CITY OF RIVERSIDE, CALIFORNIA
 DEPARTMENT OF PUBLIC WORKS

STREET PLAN & PROFILE
SUNRISE PLACE
 RECORD OF SURVEY 28/55
 SCALE: AS SHOWN

NO. **R-650**
 SHEET 1 OF 1

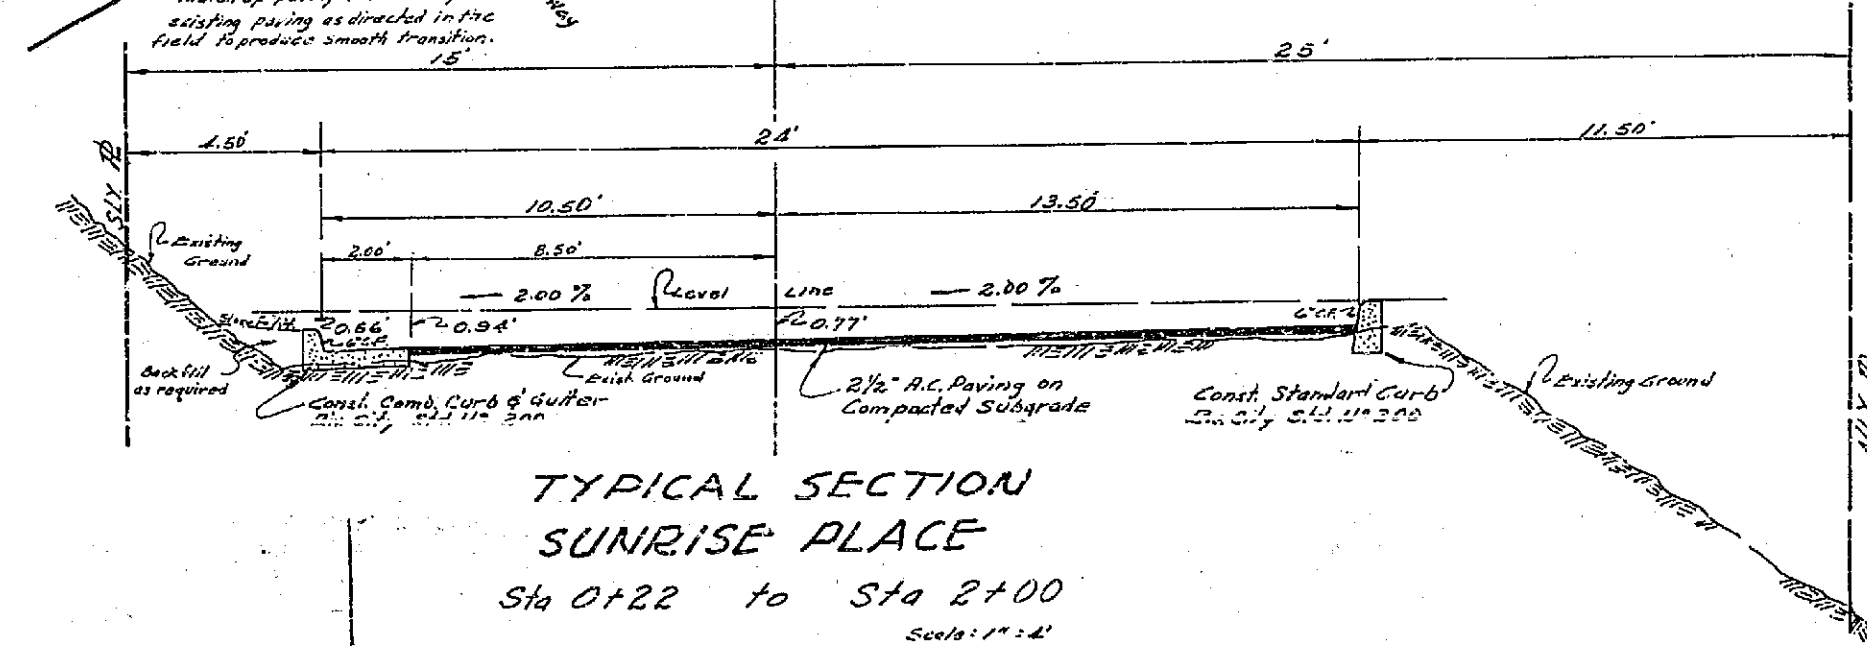
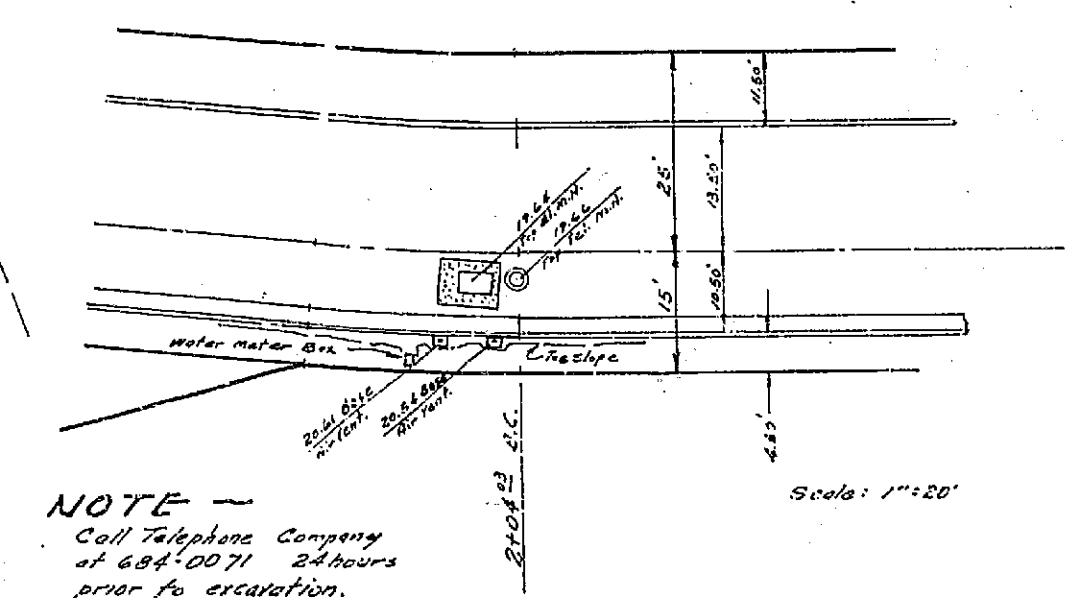
REVISIONS	
MARK	DATE
①	6-8-68
	Increase both curbs from 12" to 18" in height. Approved by Director of Public Works.
